RHODE ISLAND DEPARTMENT OF TRANSPORTATION

Bridge Group 54A -Kingston Rd Bridge

NOTICE TO PROSPECTIVE BIDDERS

ADDENDUM NO. 1 Prospective bidders and all concerned are hereby notified of the following changes in the Plans, Specifications, Proposal and Distribution of Quantities for this contract. These changes shall be incorporated in the Plans, Specifications, Proposal and Distribution of Quantities, and shall become an integral part of the Contract Documents.

KINGSTON ROAD BRIDGE No. 403
SIGNAL PLAN NO. 4
STOP & SHOP PLAZA & KINGSTOWN ROAD
EXISTING SIGNAL NO. 746

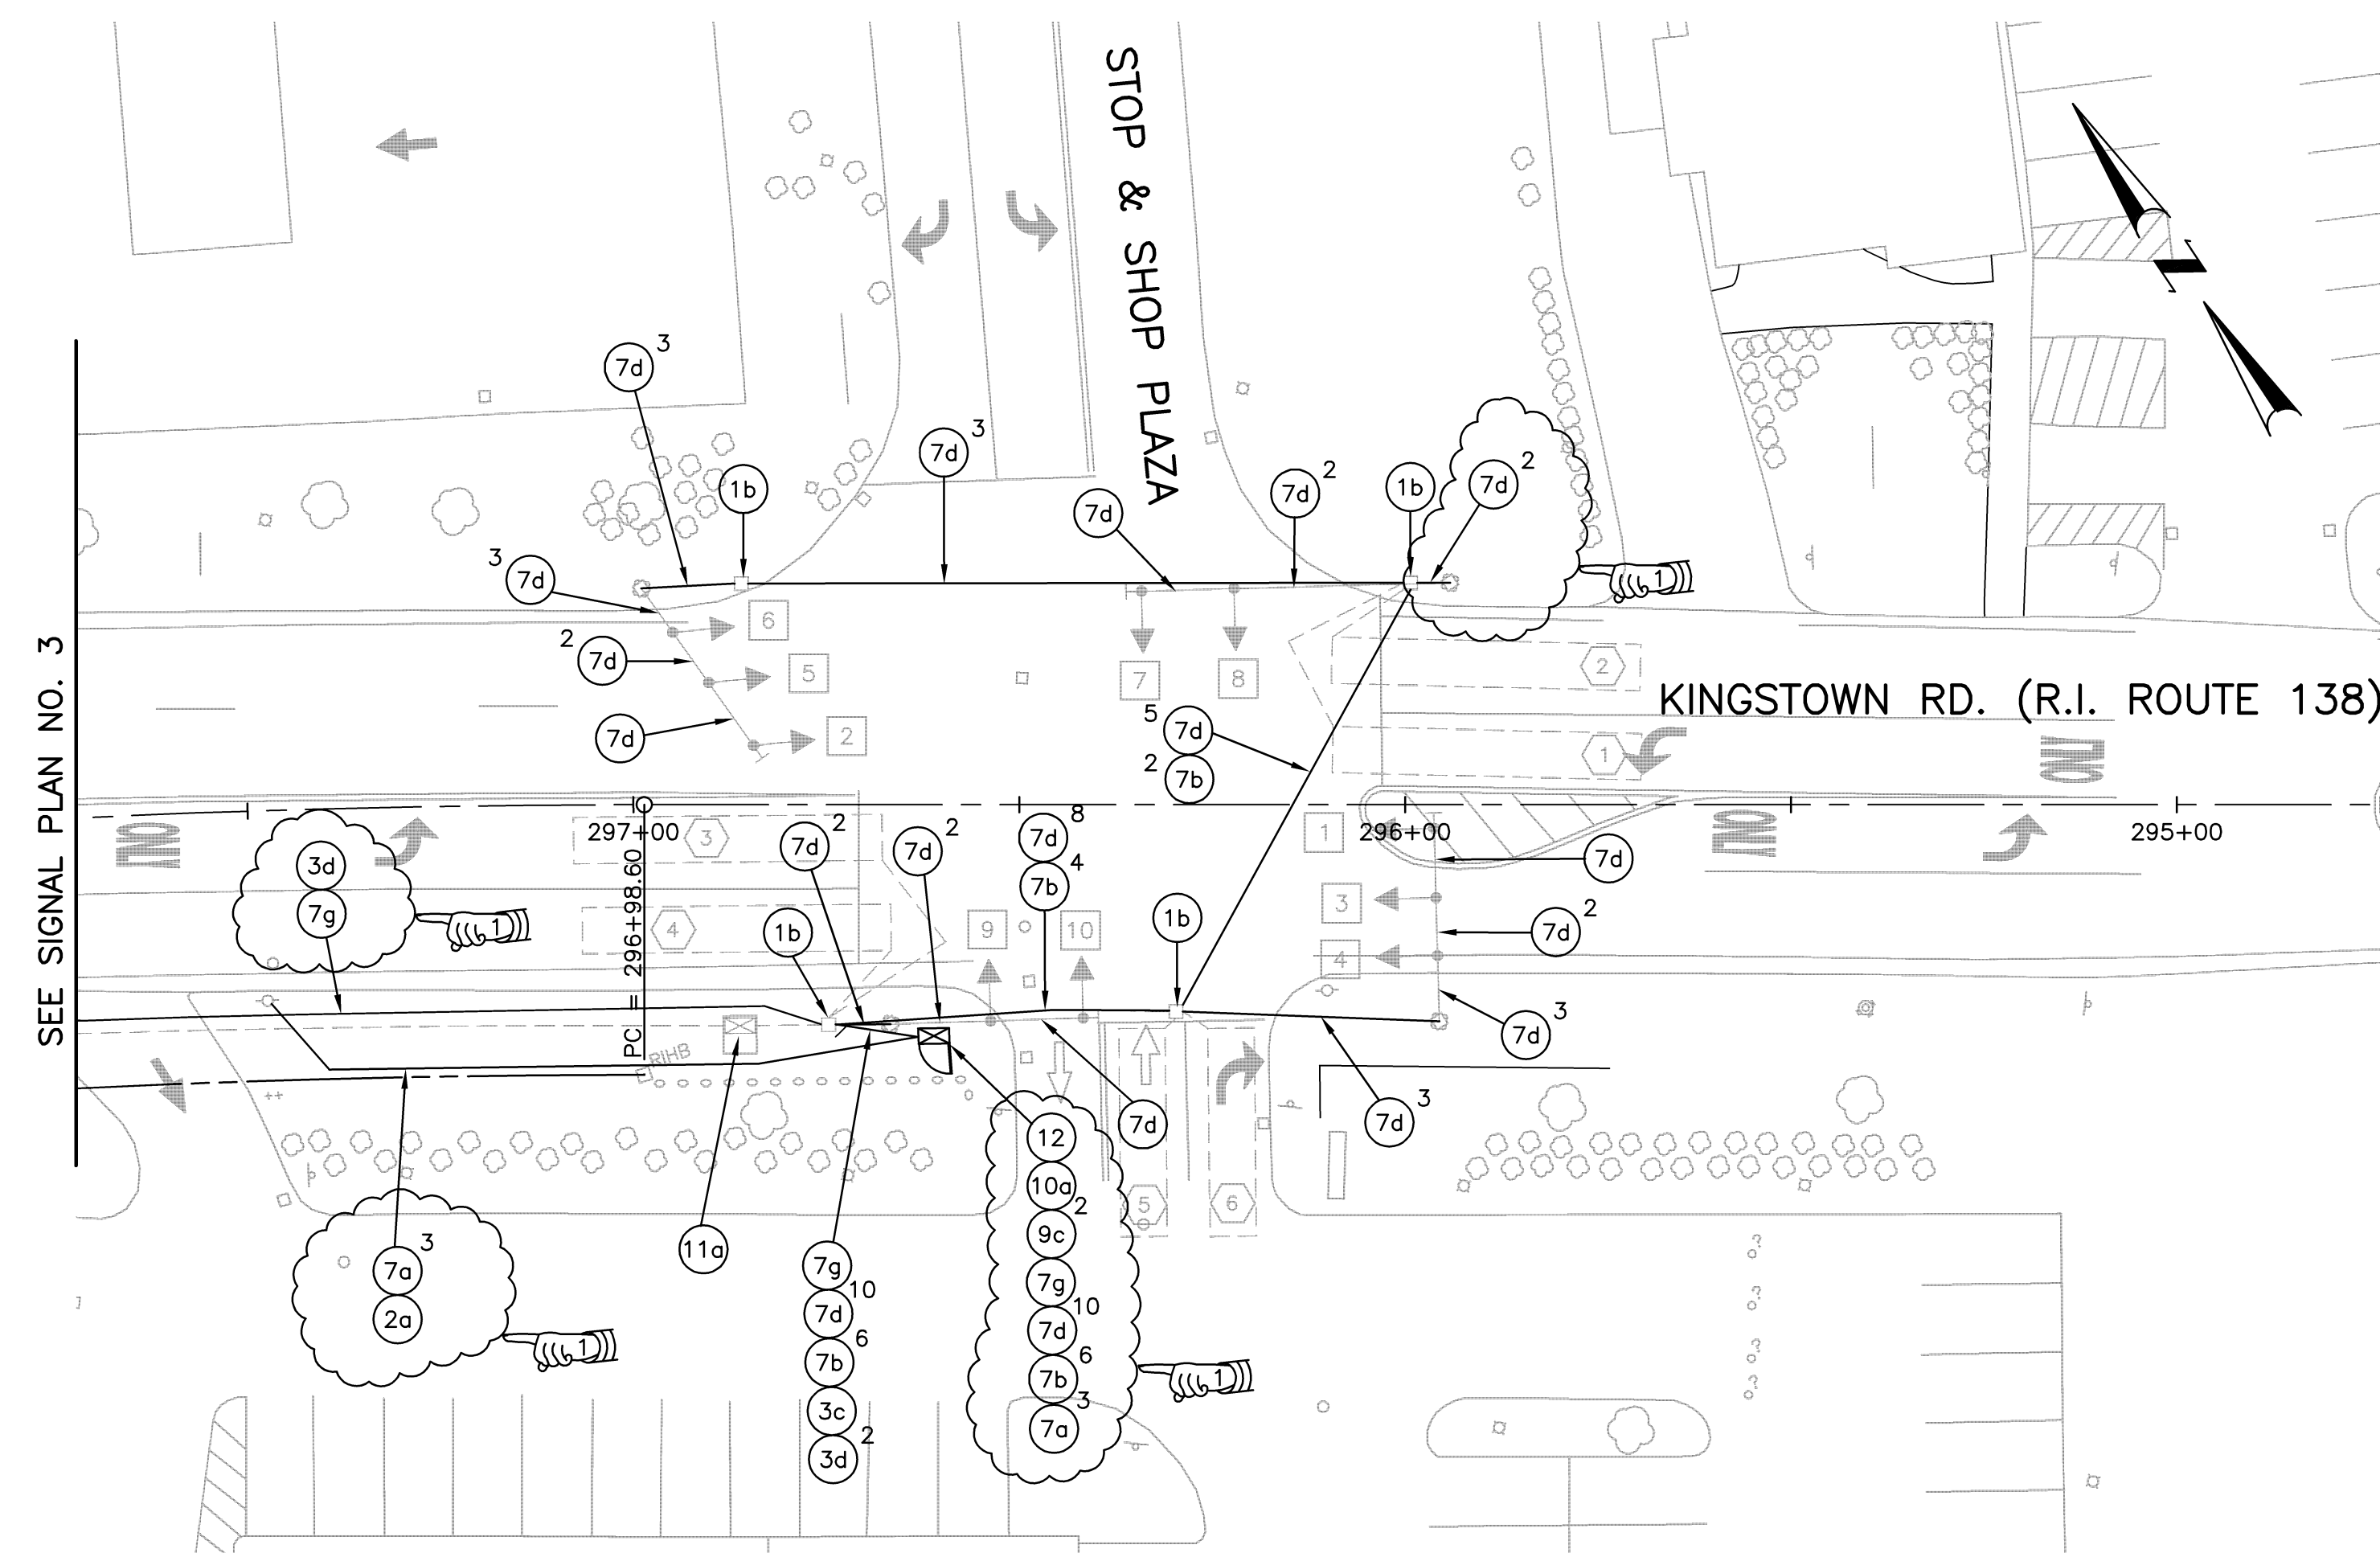
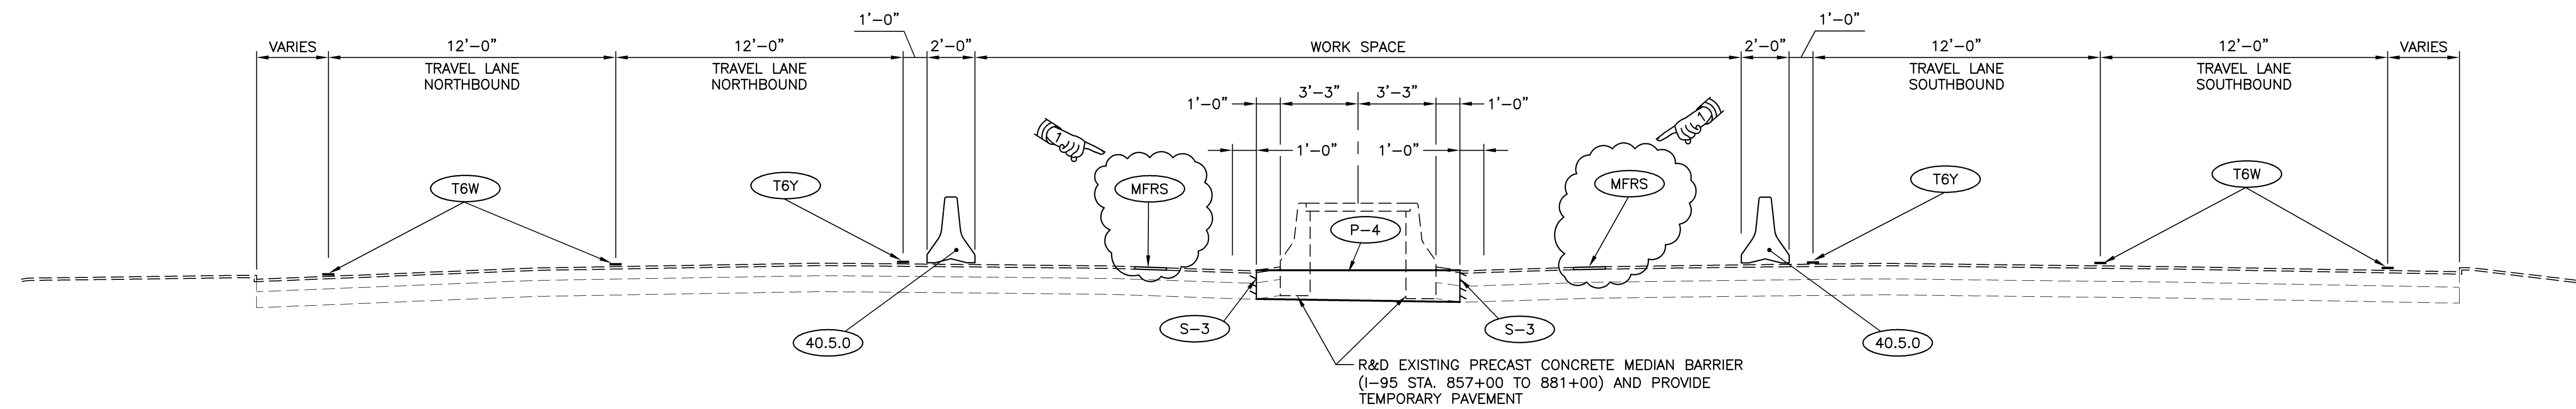
Remove Volume 1 Sheet No. 108 in its entirety and replace it with revised Sheet No. 108 (R-1) attached to this Addendum No. 1. The Item Number Legend and Signal Plan has been revised.

TYPICAL SECTION
REMOVE MEDIAN BARRIER PRIOR TO PHASE 1 BRIDGE CONSTRUCTION
I-95 STA. 857+00 TO STA. 881+00
 SCALE: 1" = 4'-0"

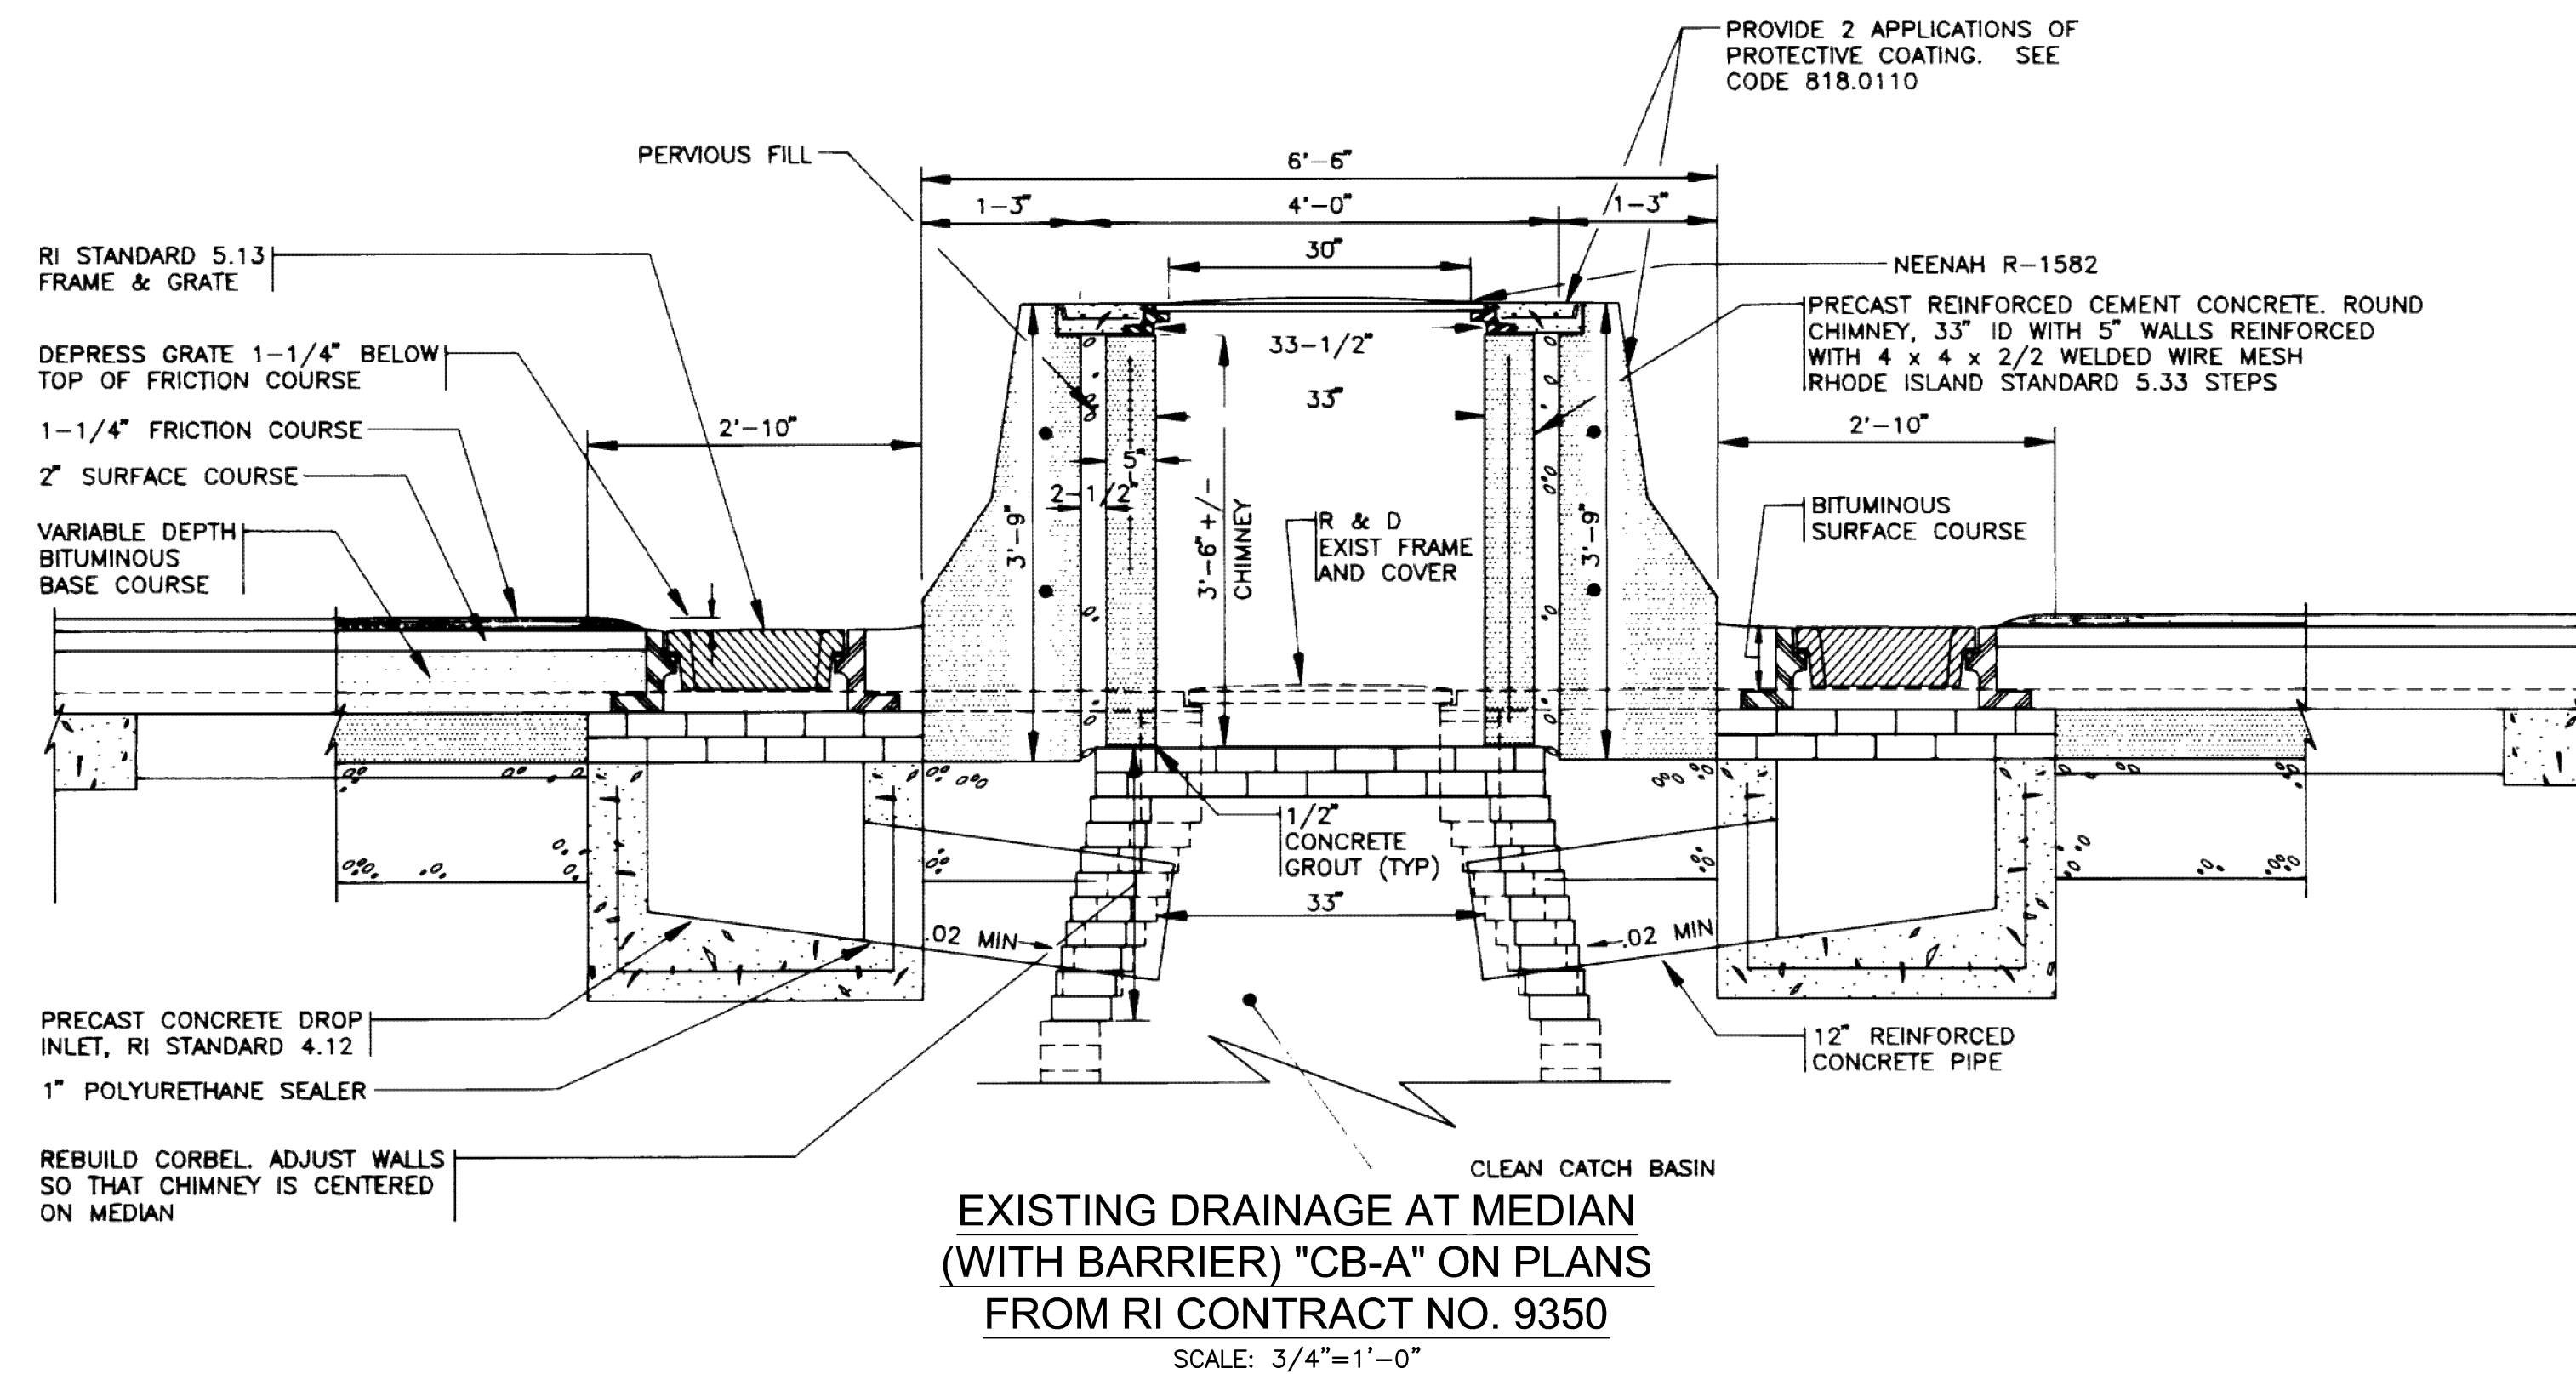
4. Volume 1 Plan Sheet No. 115 - Maintenance & Protection of Traffic Plan No. 2
Remove Volume 1 Sheet No. 115 in its entirety and replace it with revised Sheet No. 115 (R-1) attached to this Addendum No. 1. The Typical Section has been revised.
5. Volume 2 Plan Sheet No. 16 - GRS Wall Details
Remove Volume 2 Sheet No. 16 in its entirety and replace it with revised Sheet No. 16 attached to this Addendum No. 1. The North GRS Abutment Section has been revised.
6. Volume 2 Plan Sheet No. 29 - Diaphragm Details
Remove Volume 2 Sheet No. 29 in its entirety and replace it with revised Sheet No. 29 (R-1) attached to this Addendum No. 1. The End Diaphragm (D-1) detail has been revised.
